Youth Music Project

An Application For: Conditional Use Permit Class II Design Review

Supplemental Information

In response to November 26 Letter: City of West Linn List of Incomplete Items Submitted December 23, 2013

SITE PLAN

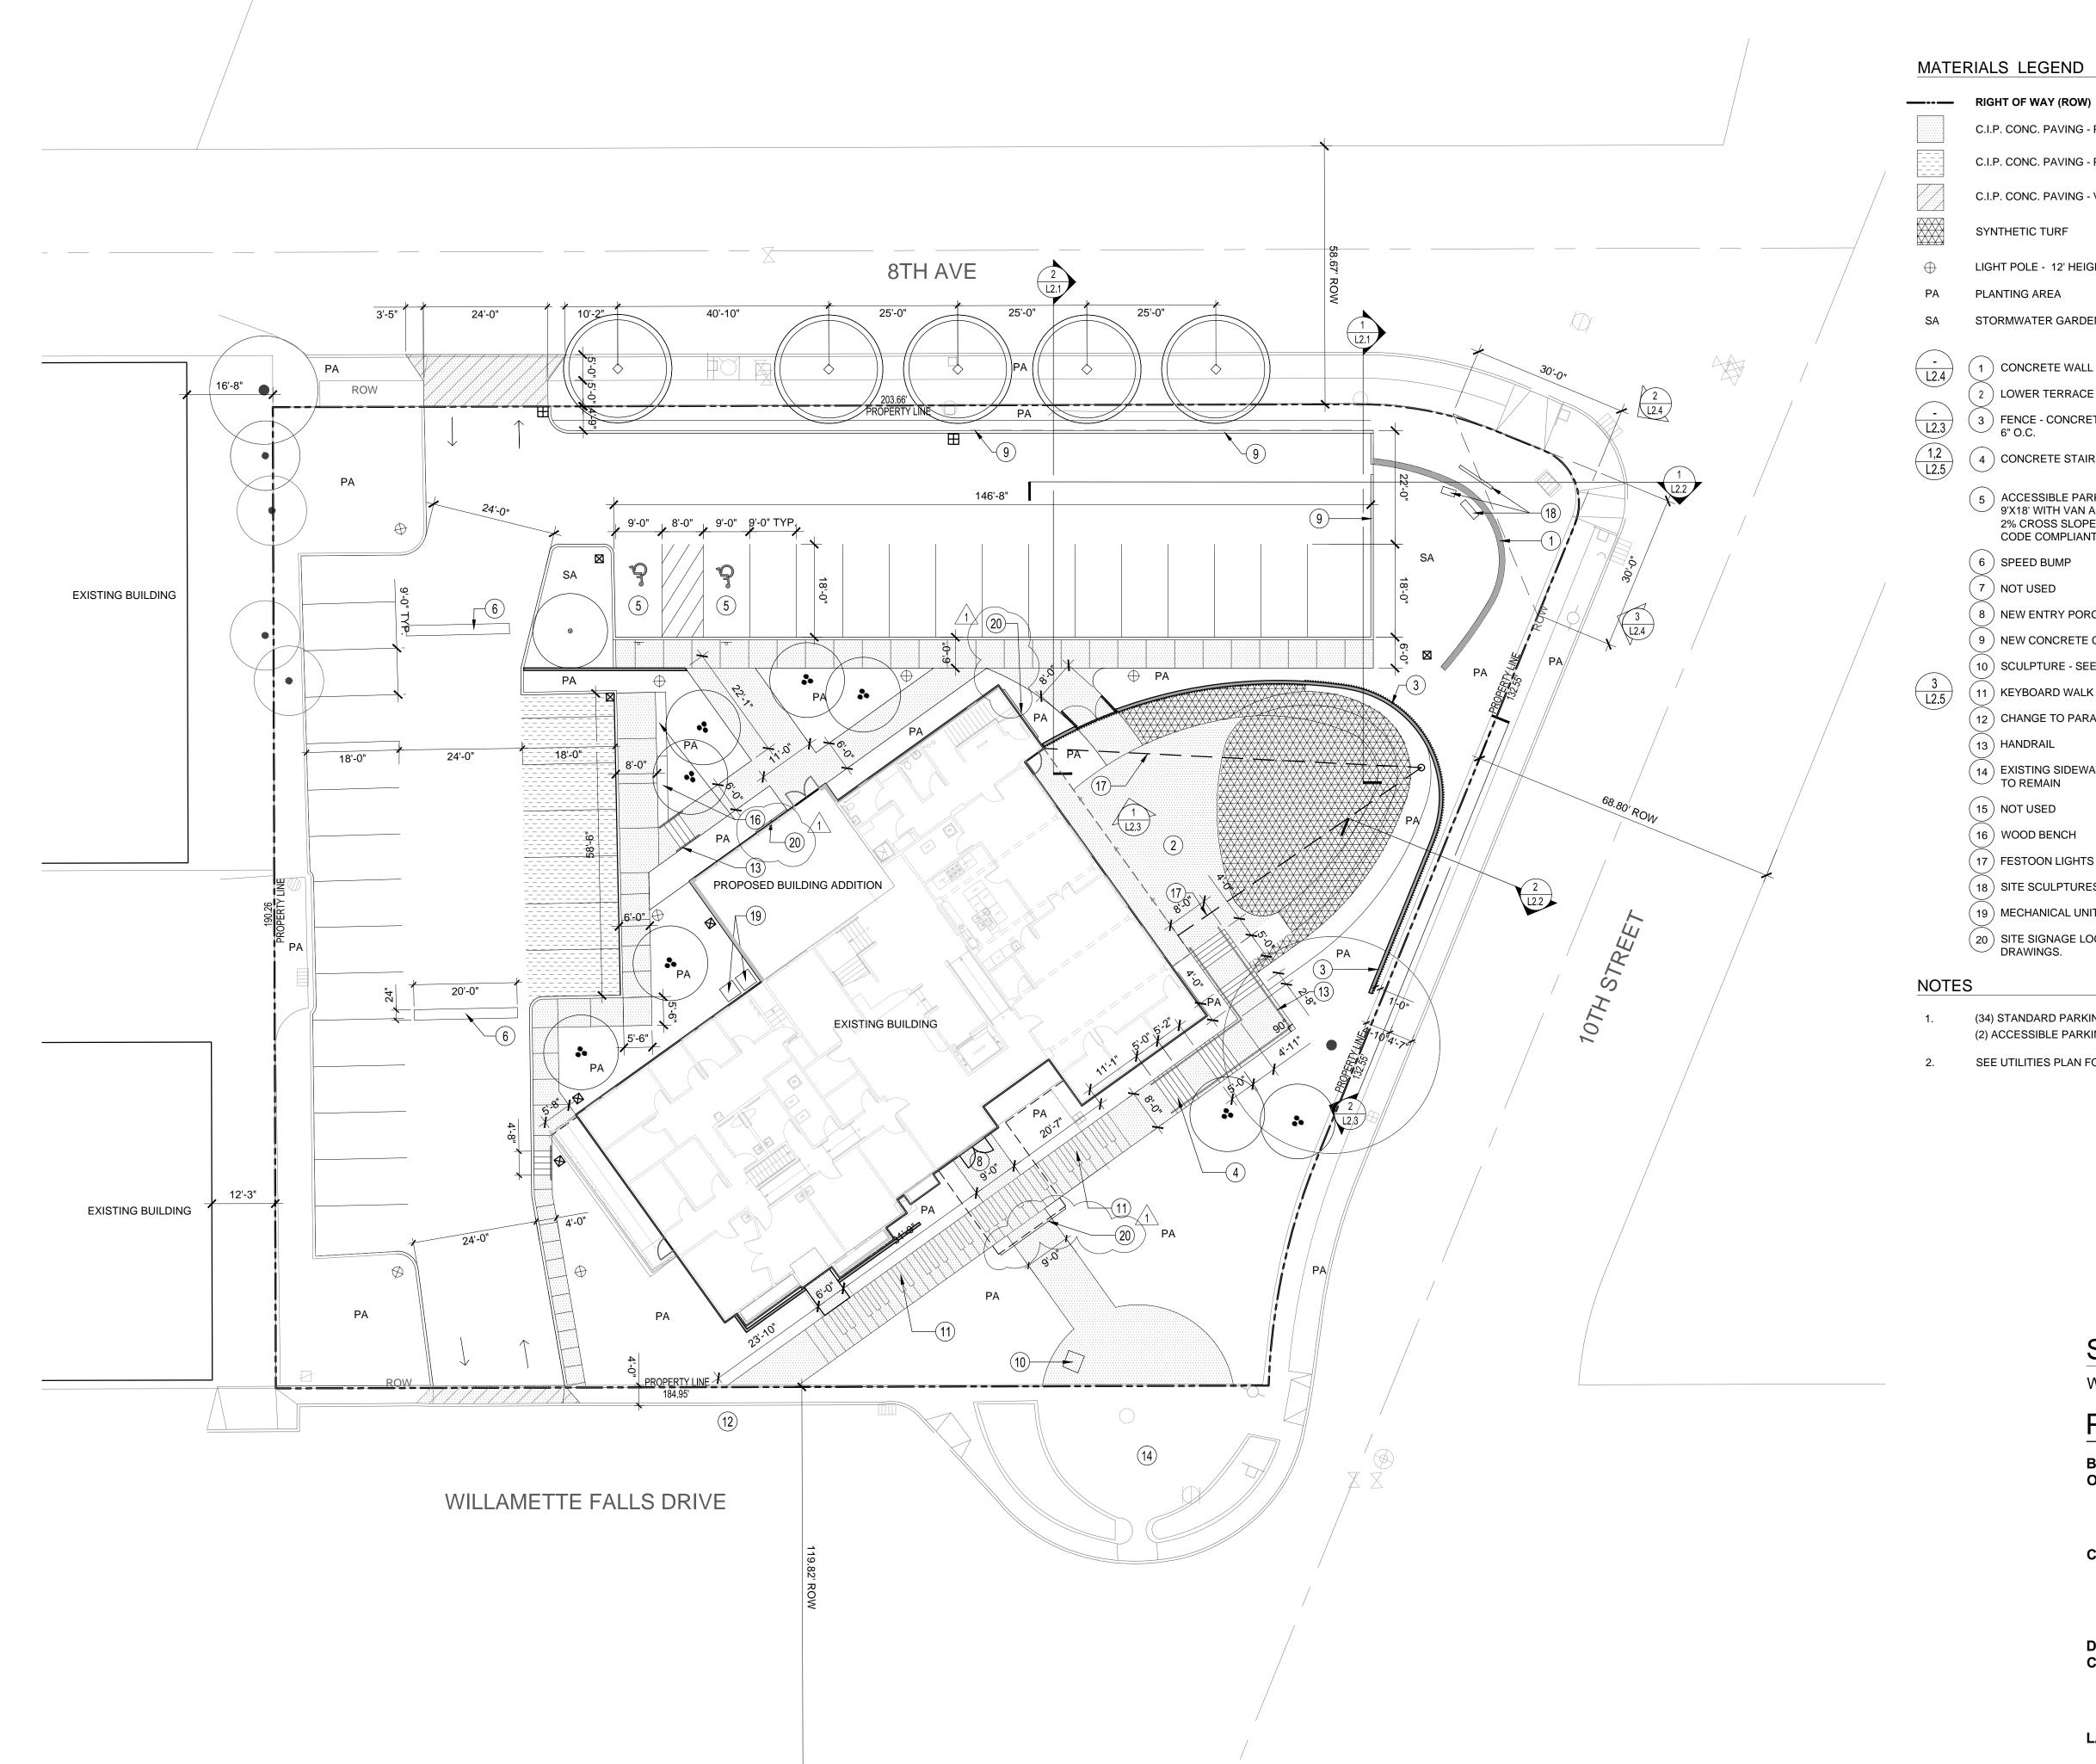
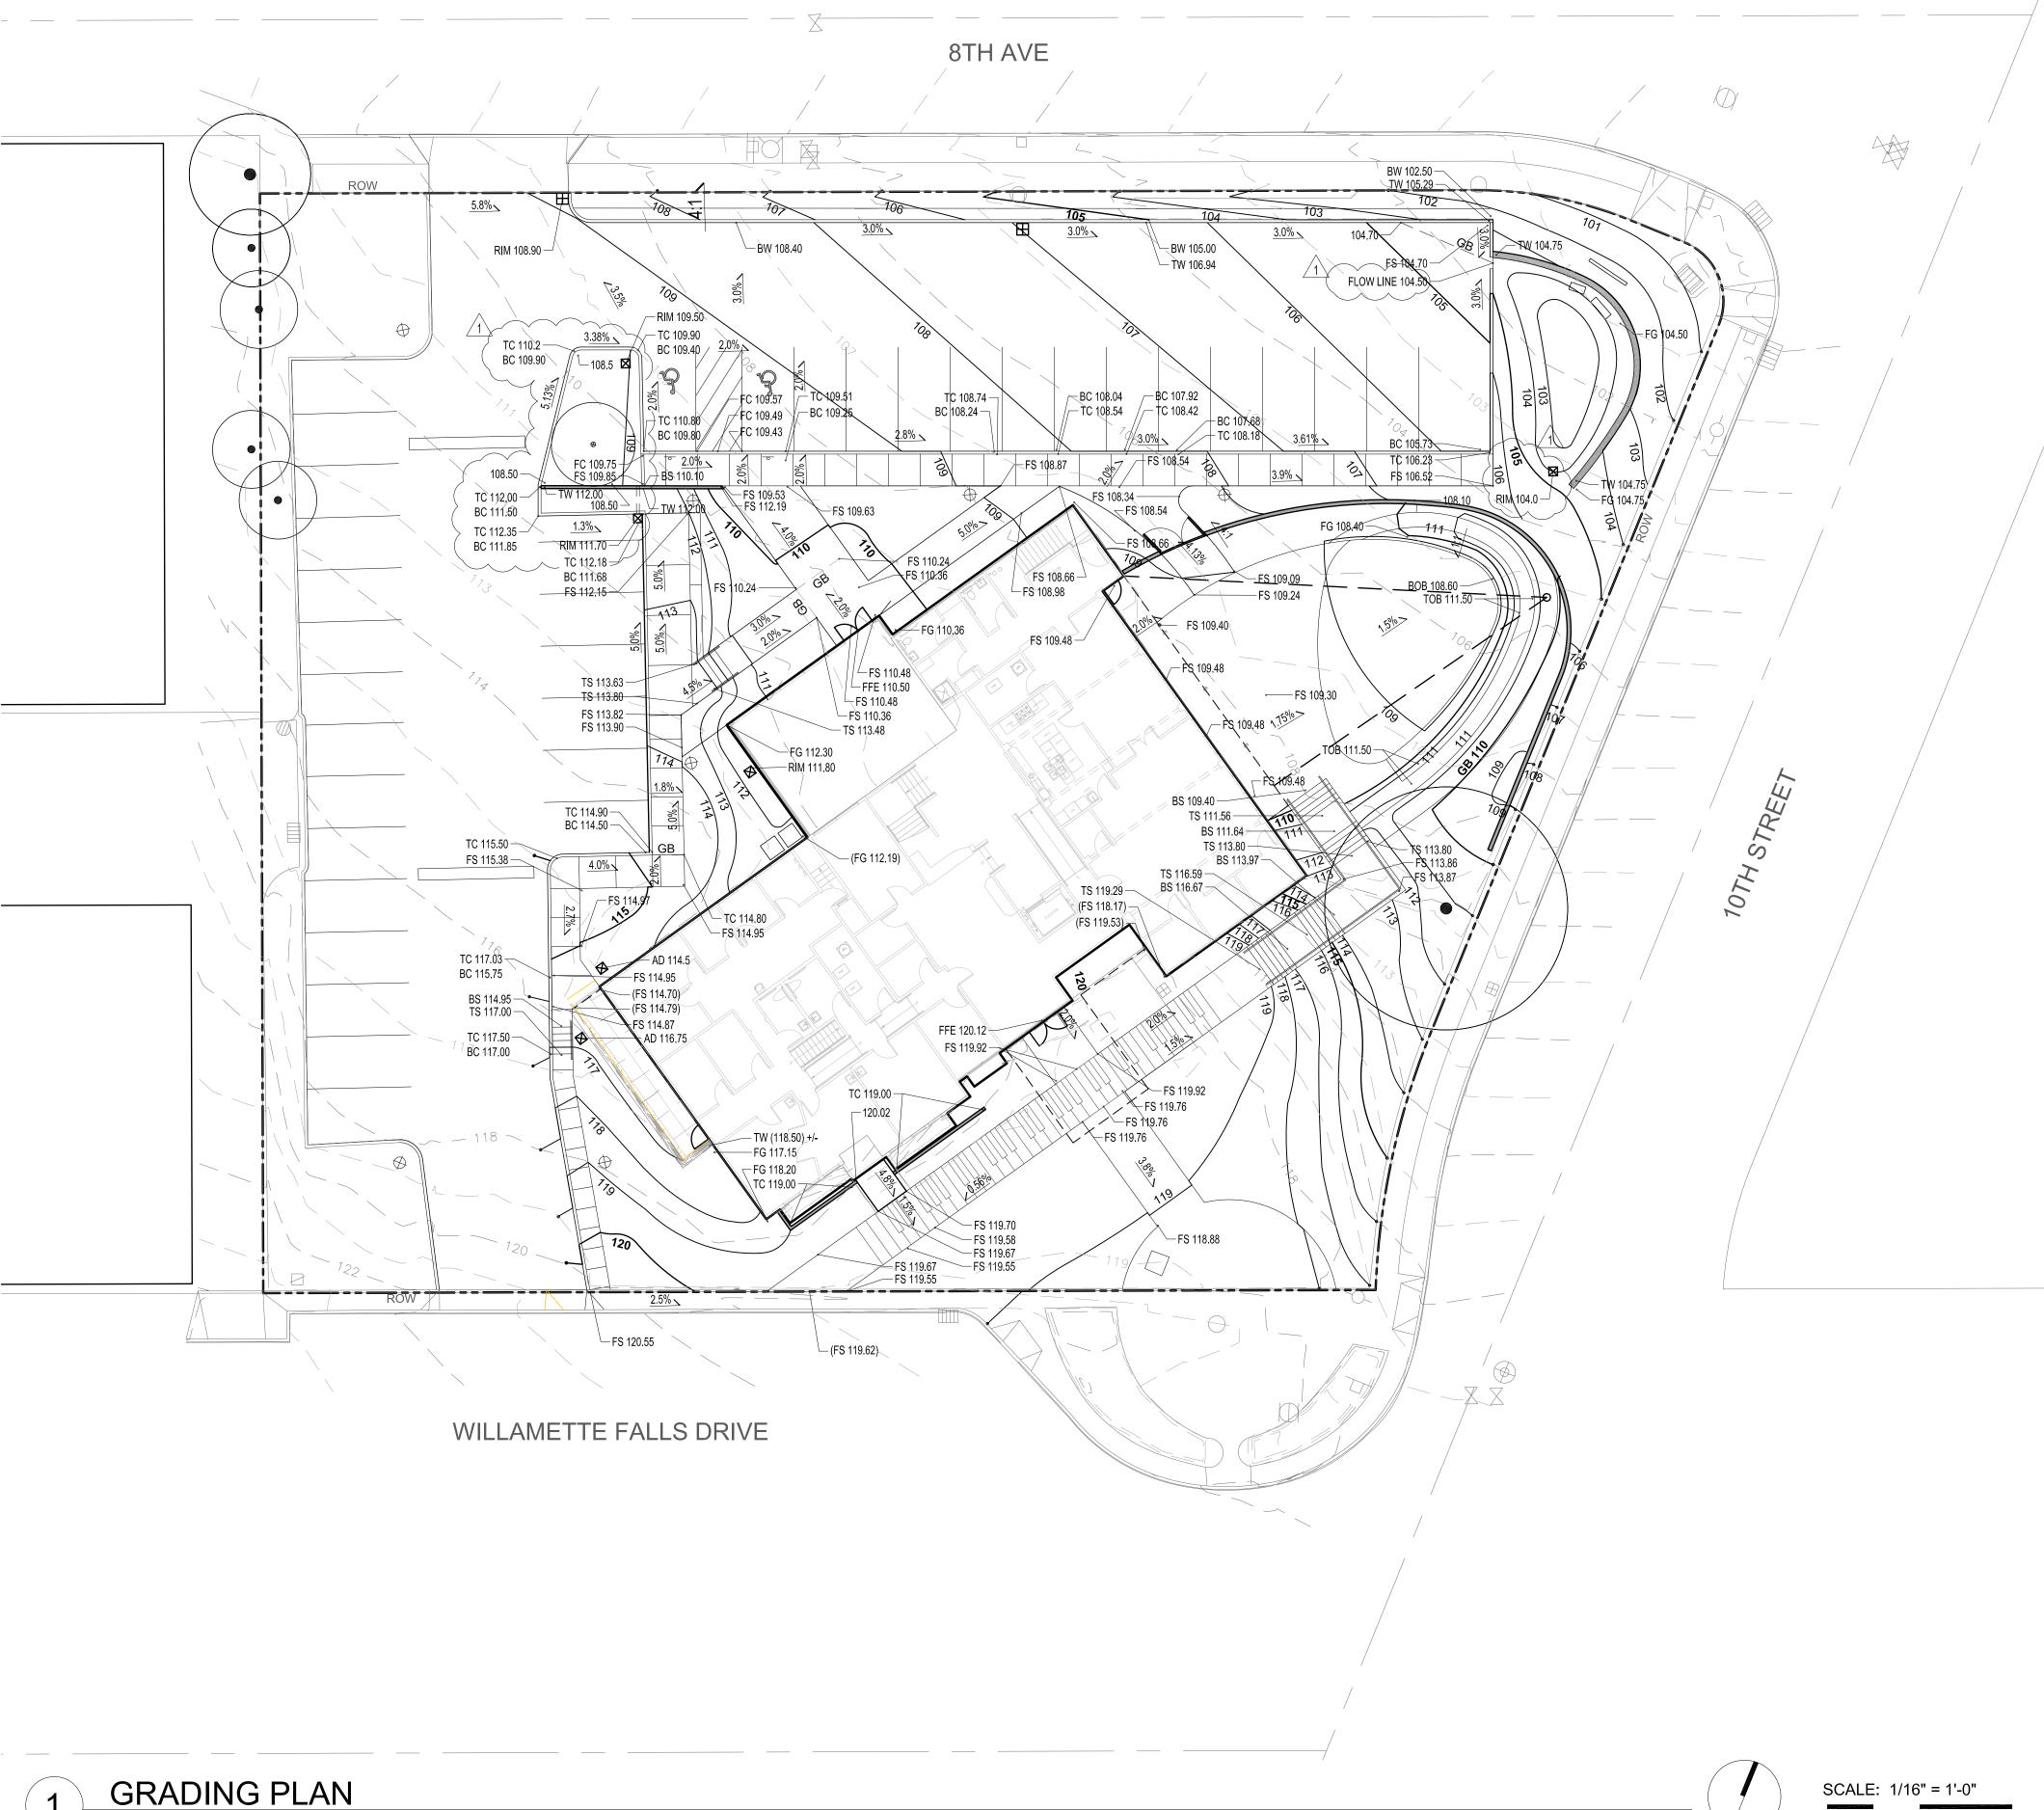
Put sign locations on site plan (i.e. indicating on building footprint edge where they will be, etc.).

• See Attachment D – Landscape Drawings: L1.2 Site Plan

Sheet Name STORM DRAIN PLAN

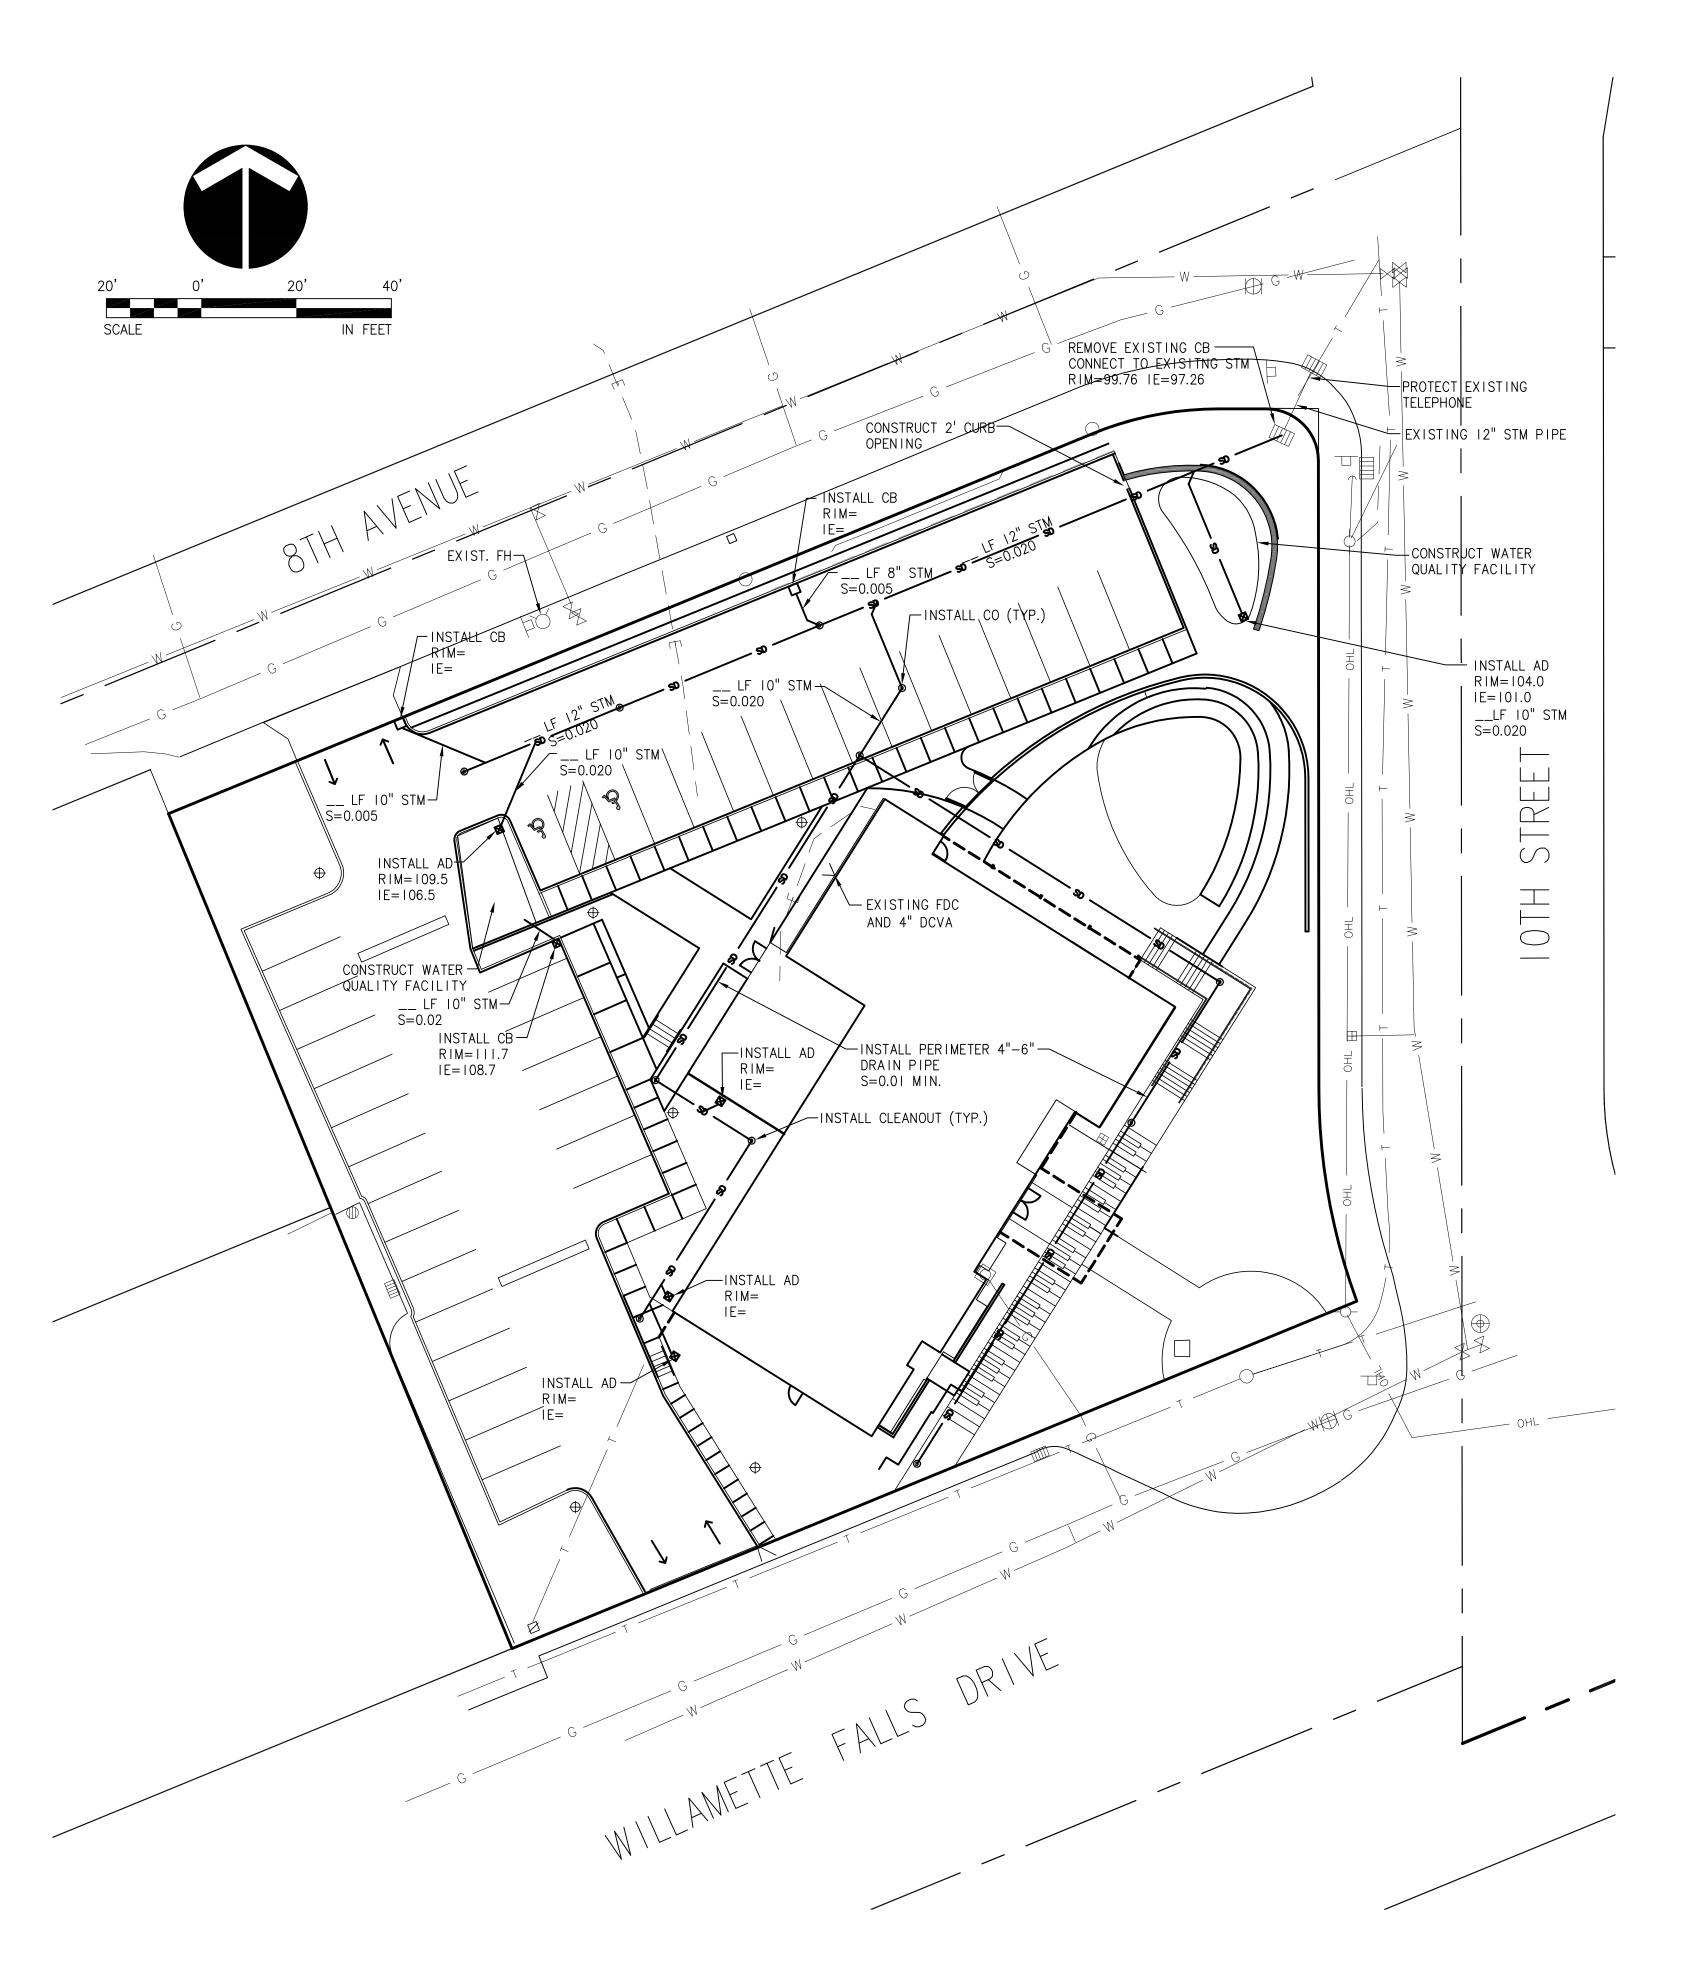
Submit a storm drainage report. Since the building is being expanded, new impervious area must be included in the report.

- P3.0 Storm Drain Plan
- P3.1 Storm Drain Notes and Details
